FINAL PLAT
HAWTHORNE ADDITION
AN ADDITION TO WICHITA, SEDGWICK COUNTY, KANSAS

RE: SUB 2002-56 -- Final Plat of Hawthorne Addition

RE: SUB 2002-56 -- Final Plat of Hawthorne Addition

CASE NUMBER: SUB 2002-56 -- HAWTHORNE ADDITION

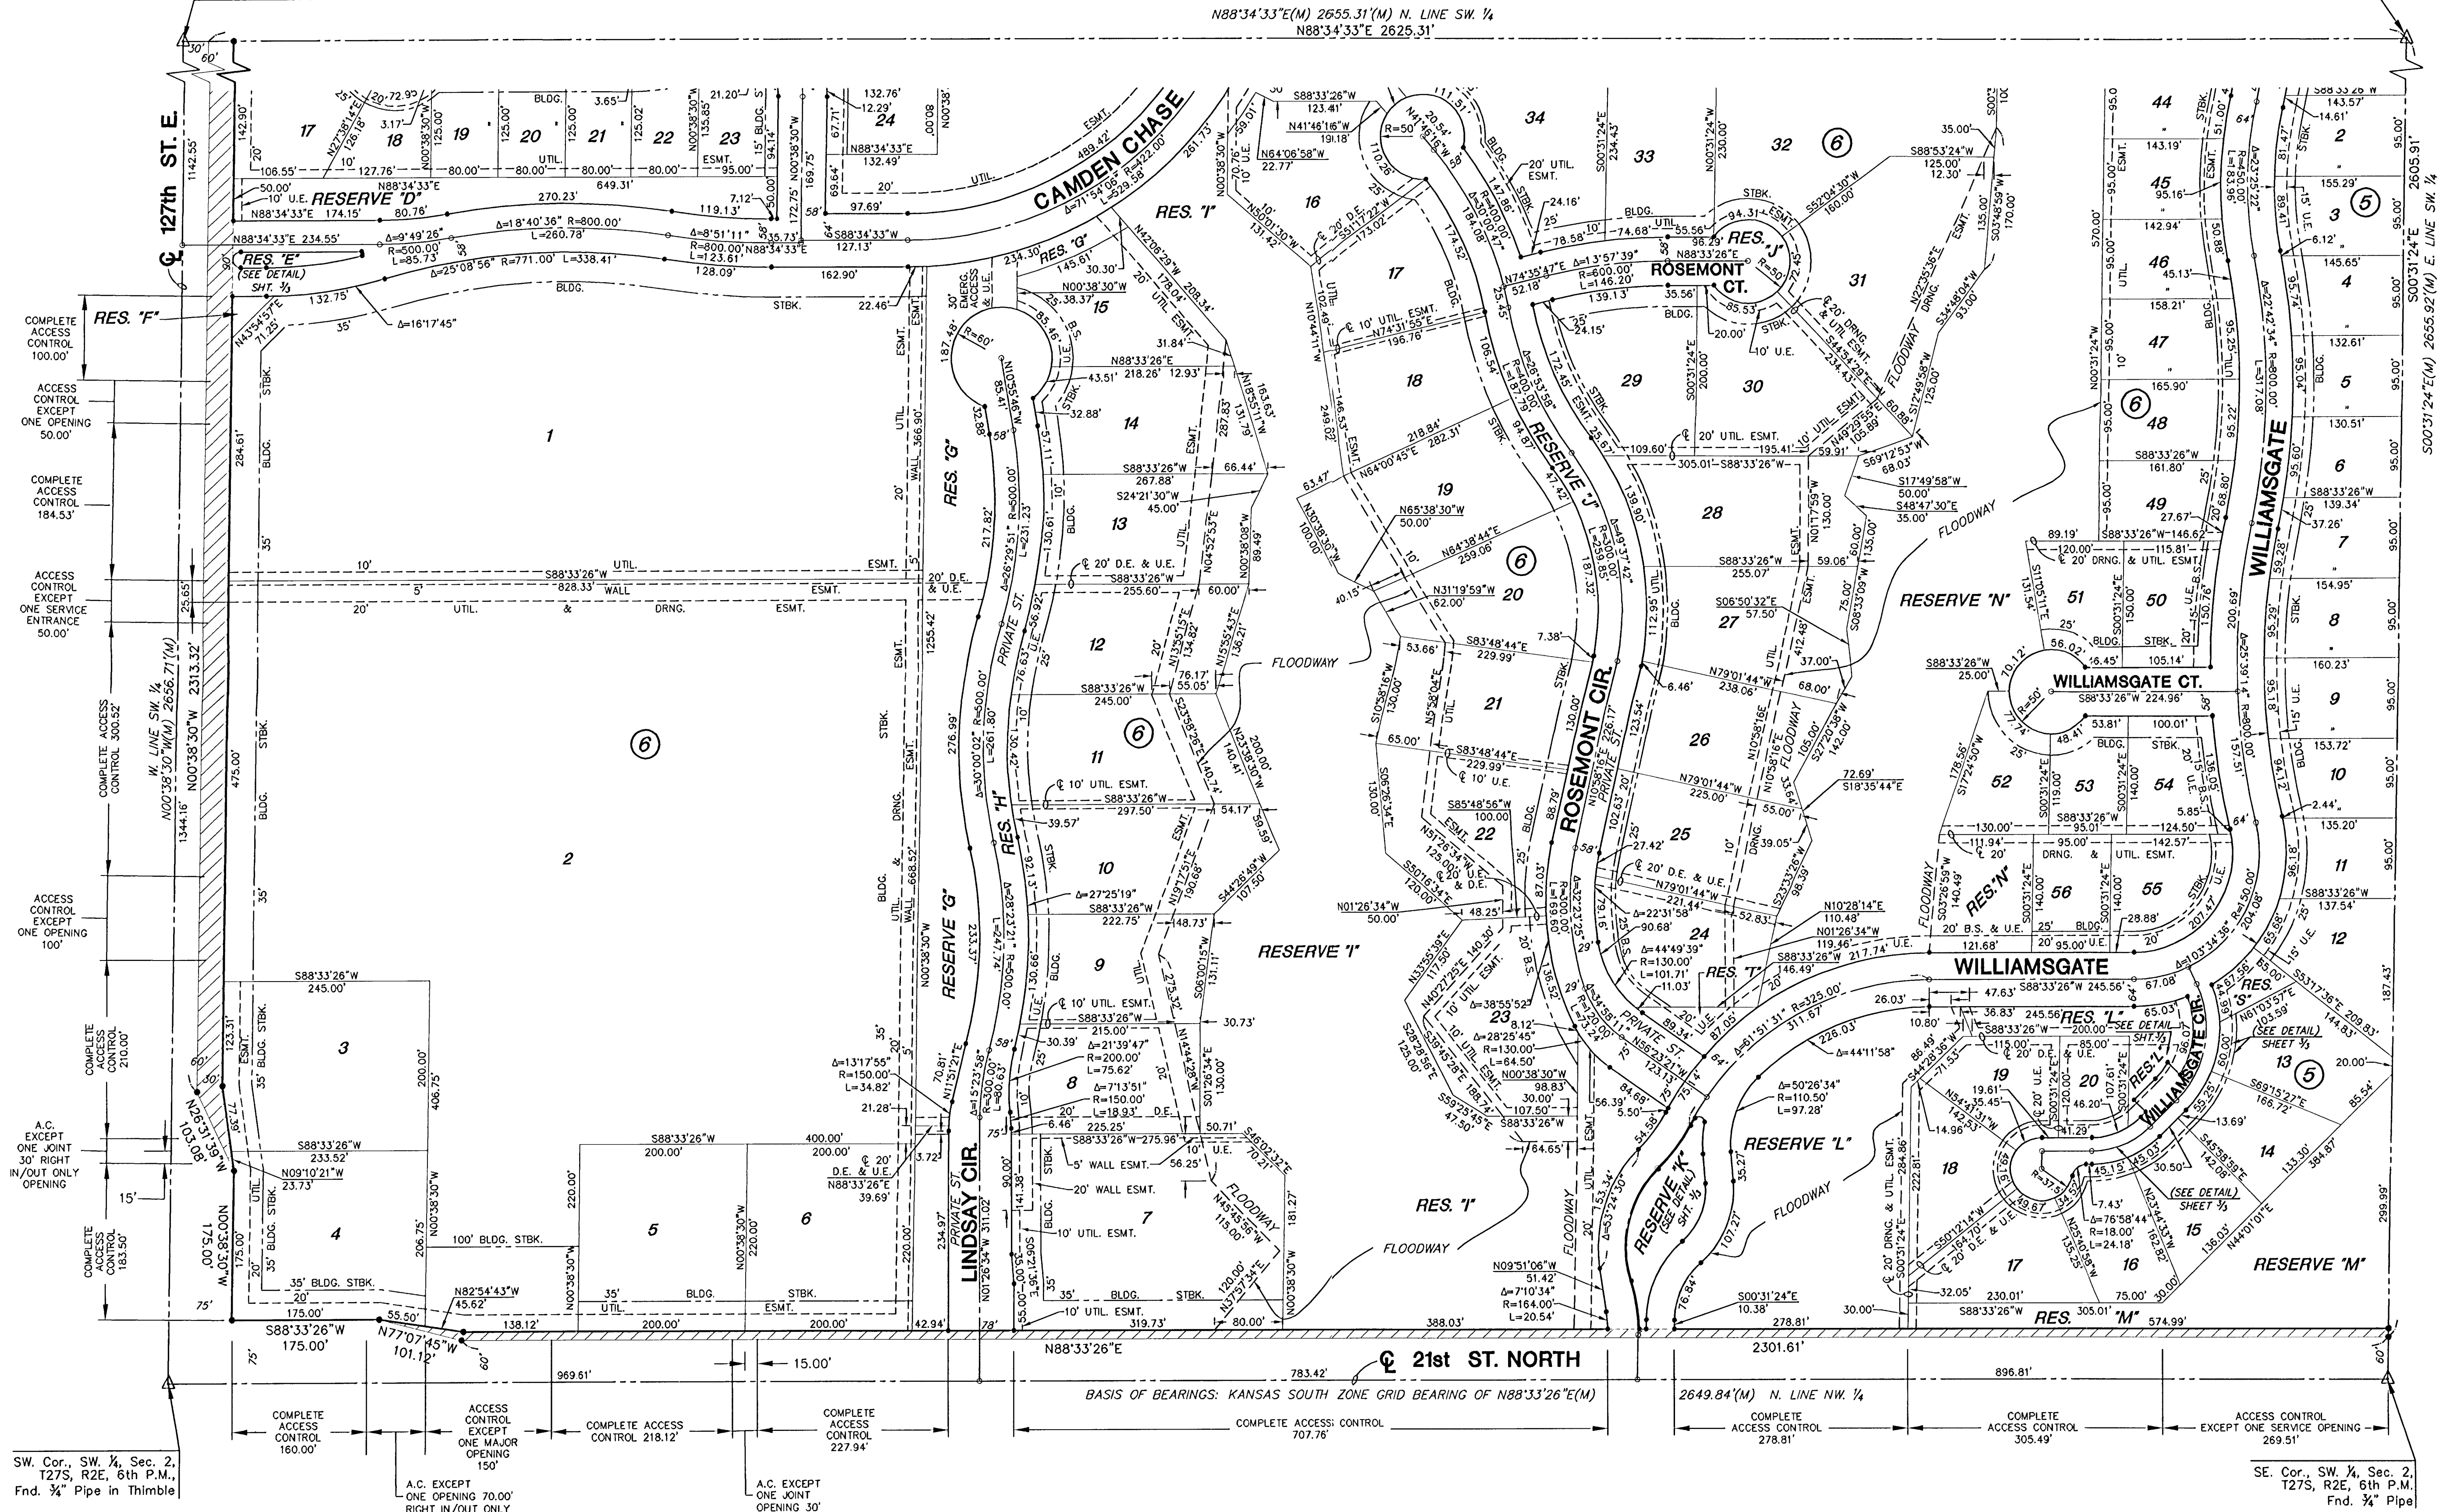
- D. The drainage plan is approved. A guarantee is required.
- E. The approved CUP permitted 4 openings along 127th St. East and three openings along 21st St. The CUP also required joint access openings between Lots 3 and 4, and between Lots 5 and 6. Right turns only were required for the openings closest to the intersection. The access controls on the plat conform with the CUP. The dedication of access controls in the plat's text shall reference Block 6.

- H. The applicant shall guarantee the installation of the private streets, Lindsay Circle, Rosemont Circle and Rosemont Court, to a public street standard. As private improvements, such guarantee shall not be provided through the use of a petition.

- J. No Parking is permitted along both sides of the 58-ft segment of Camden Chase located north of Lot 1, Block 6.
- K. The applicant shall guarantee the paving of the proposed interior streets. This guarantee shall also provide for sidewalks along both sides of Camden Chase/Hawthorne which functions as a collector, along one side of the through non-cul-de-sac streets (Peckham and Williamsgate) and along one side of the loop street.

- M. Reserves Q and S need to be referenced in plat's text.
- N. Because of the landlocked nature of Reserve M being platted in the southeast corner of the site, a means of access shall be provided to such a Reserve.

An opening has been platted along 21st Street. This opening needs to be labeled as a "service opening".
- O. Provisions shall be made for ownership and maintenance of the proposed reserves. The applicant shall either form a lot owners' association prior to recording the plat or shall submit a covenant stating when the association will be formed, when the reserves will be deeded to the association and who is to own and maintain the reserves prior to the association taking over those responsibilities.

- S. The City Fire Department/GIS needs to comment on the plat's street names. Hawthorne shall be revised to Williamsgate. Rothbury shall be revised to Mainsgate. Rosemont Circle which extends into Block 2 shall be revised to Rosemont Ct.

- T. The applicant shall submit a copy of the instrument which establishes the pipeline easements on the property, which verifies that the easements shown are sufficient and that utilities may be located adjacent to and within the easements. Any relocation, lowering or encasement of the pipeline, required by this development, will not be at the expense of the City.

- U. The applicant's agent shall determine any setback requirements for the pipelines by researching the text of the pipeline agreements. If a setback from the pipeline easements is provided for in the pipeline easement agreements, it shall be indicated on the face of the plat.

- V. The recording information for all pipeline easements shall be indicated on the face of the plat.
- W. Based upon the platting binder, property taxes are still outstanding. Before the plat is scheduled for City Council consideration, proof shall be provided indicating that all applicable property taxes have been paid.
